S-2844
NEW CENTURY PLACE SUBDIVISION, SECTION 2
2nd Primary Approval Extension Request

STAFF REPORT
July 13, 2006

S-2844--NEW CENTURY PLACE (not to scale)

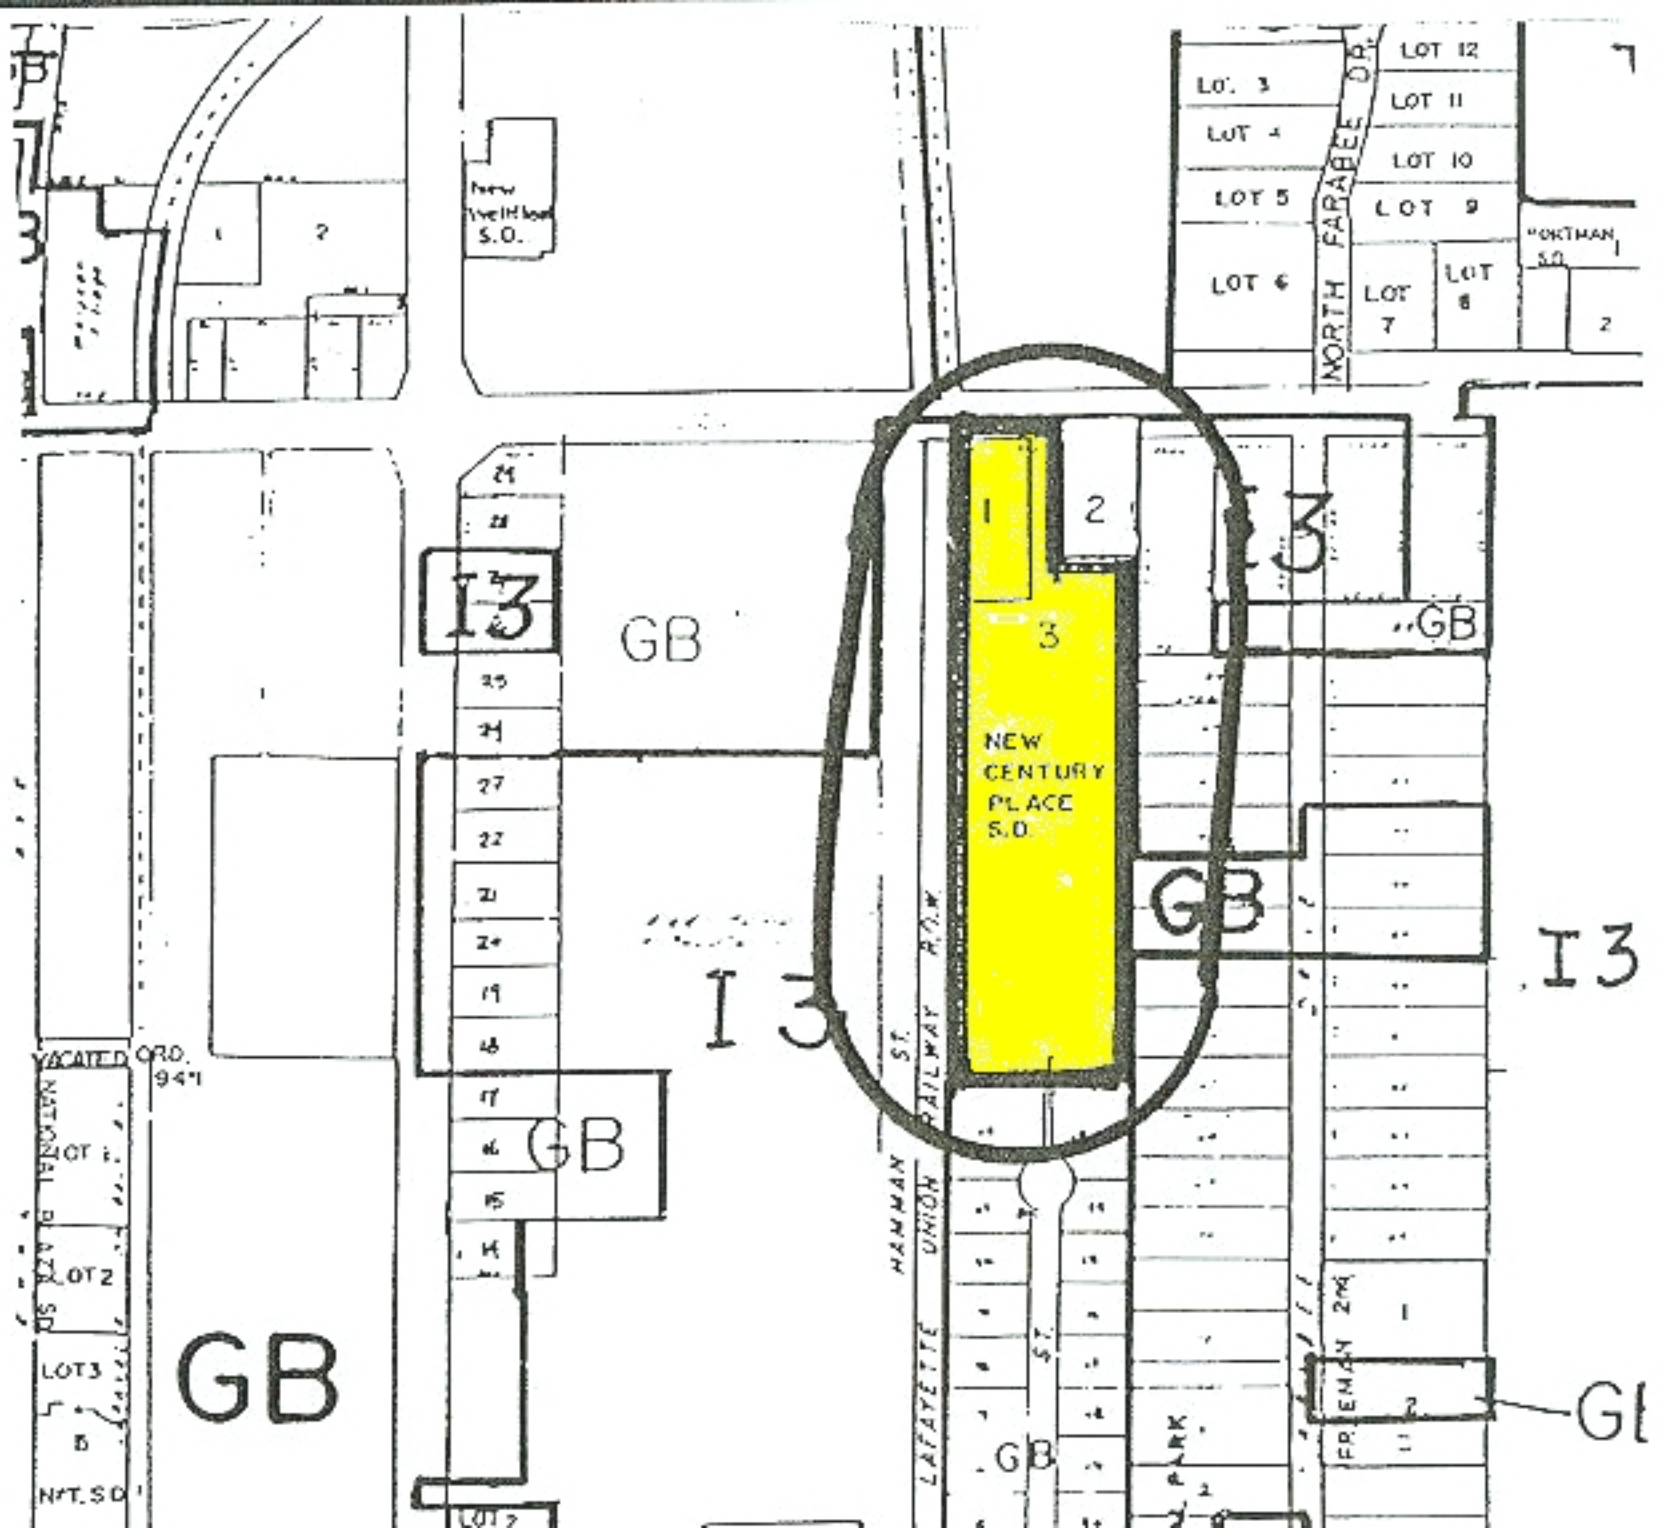
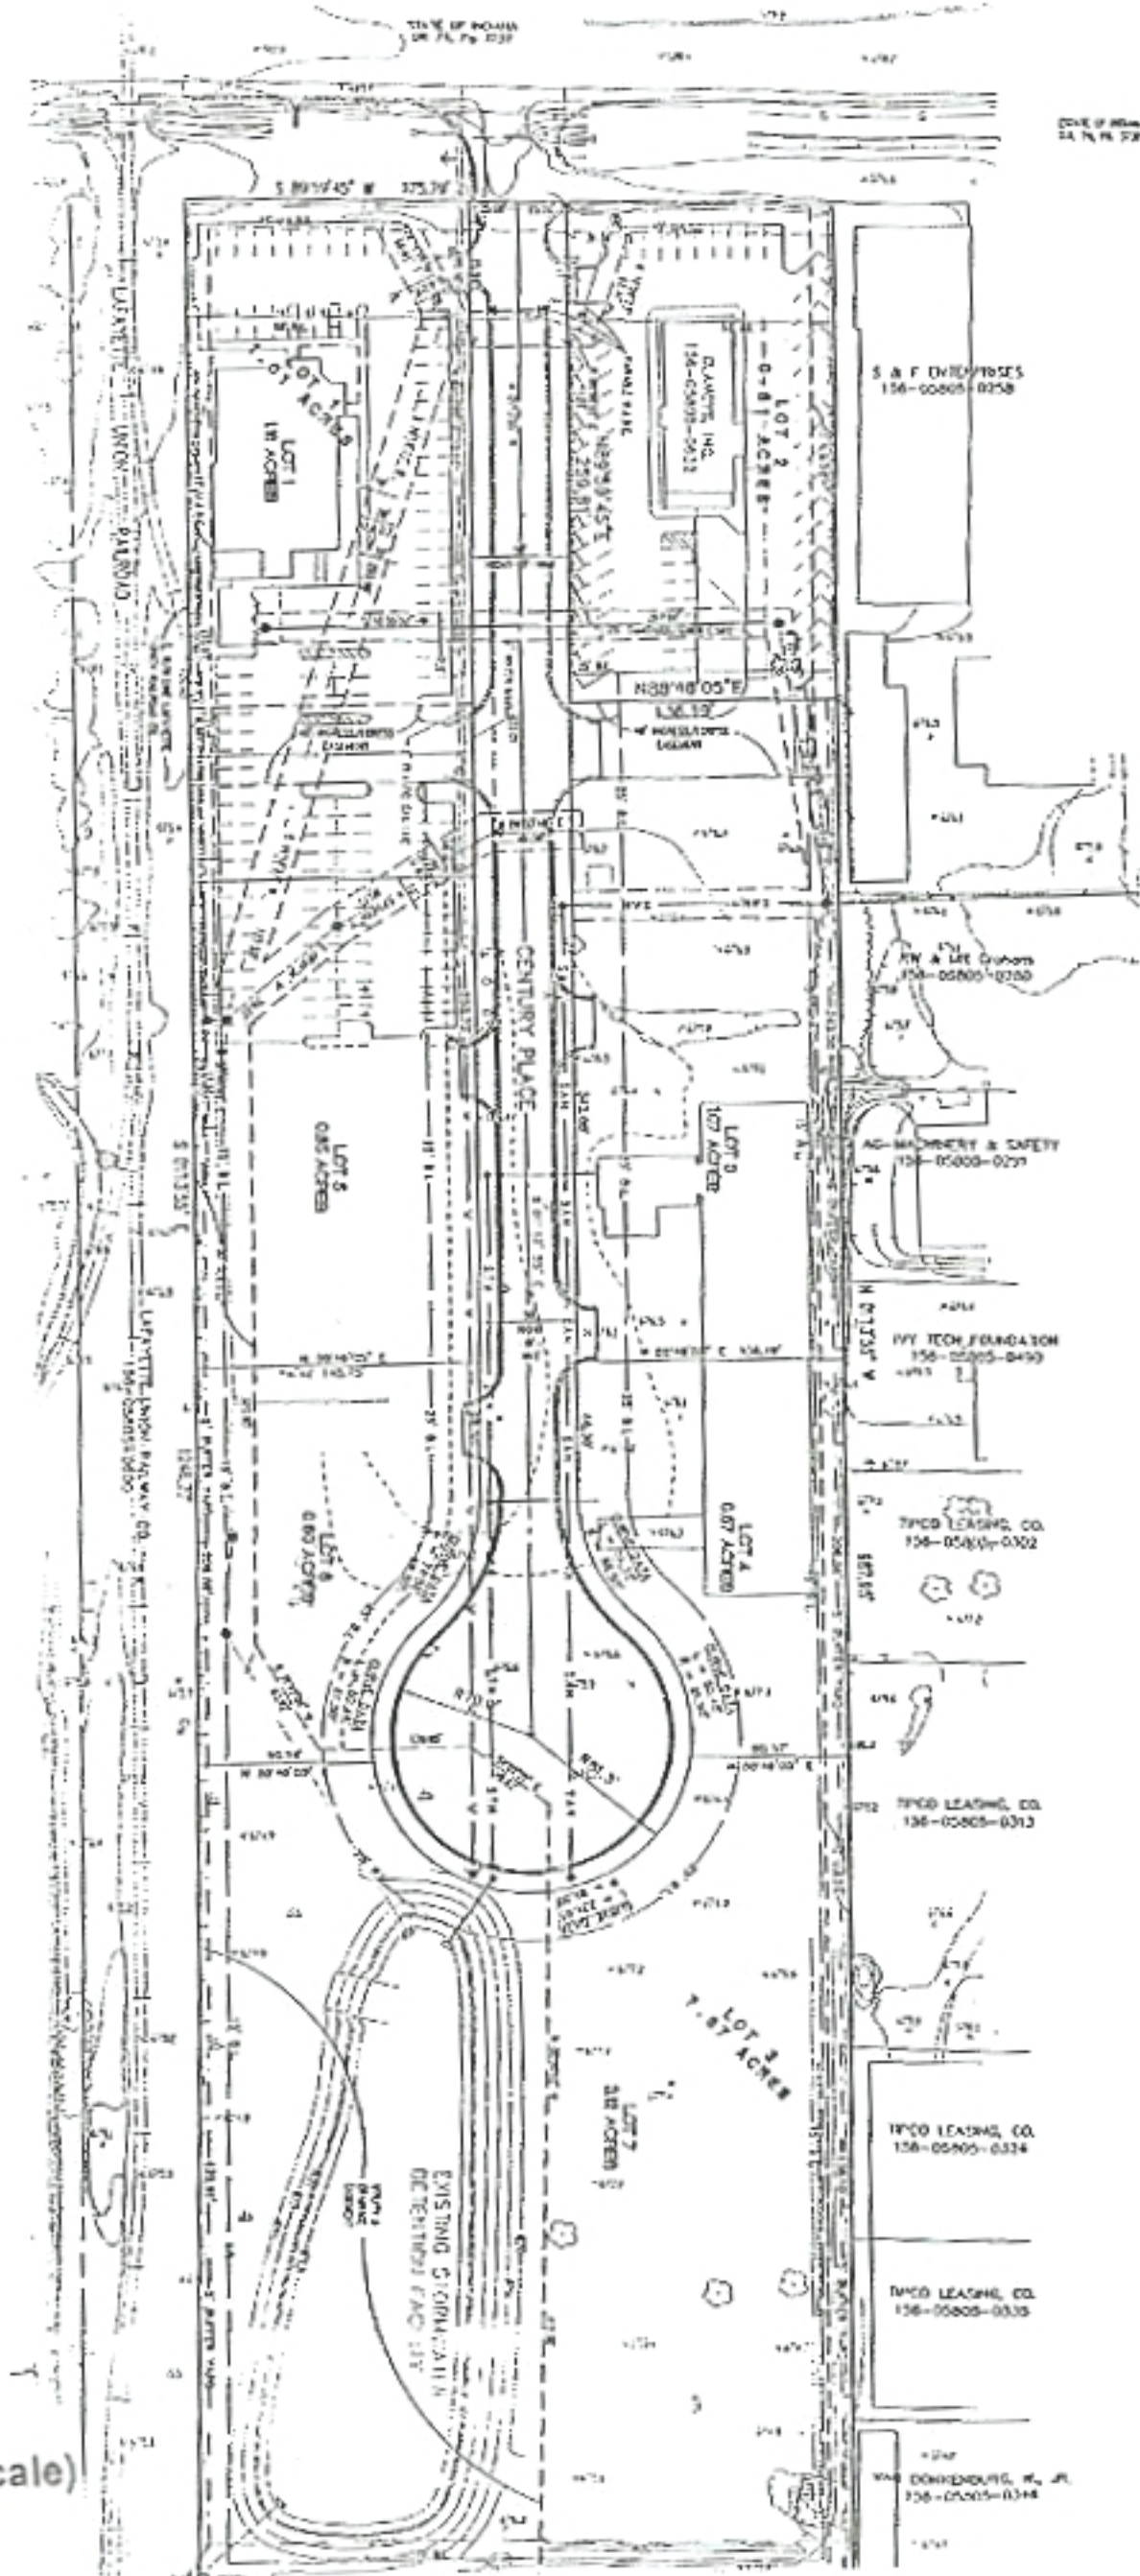
This subdivision is a replat of two commercial lots (served by a private street) into 5 lots on a public street. The construction plans were approved and a two lot final plat recorded in August 2005. The private street (Century Place) has now been upgraded and accepted as a public street, and sanitary sewer and water mains have been installed and accepted.

1. A variance to reduce the required pavement width from 34 ft. to 31 ft. (from back of curb to back of curb.) To be applied to the existing drive, between Lots 1 and 2 (Century Place).
2. A variance to reduce the required width of right-of-way from 60 ft. to 50 ft. for the existing drive, between Lots 1 and 2.
3. A variance to waive the installation of sidewalks on the West Side of Century Place.

1. For the new street extension, beyond Lot 1, Century Place shall be built to the 34 ft. wide USO standard (measured from back of curb to back of curb) and platted with a 60 ft. wide right-of-way. These shall be shown in the construction plans and on the final plat.

Approval, contingent on any applicable conditions of the original primary approval.
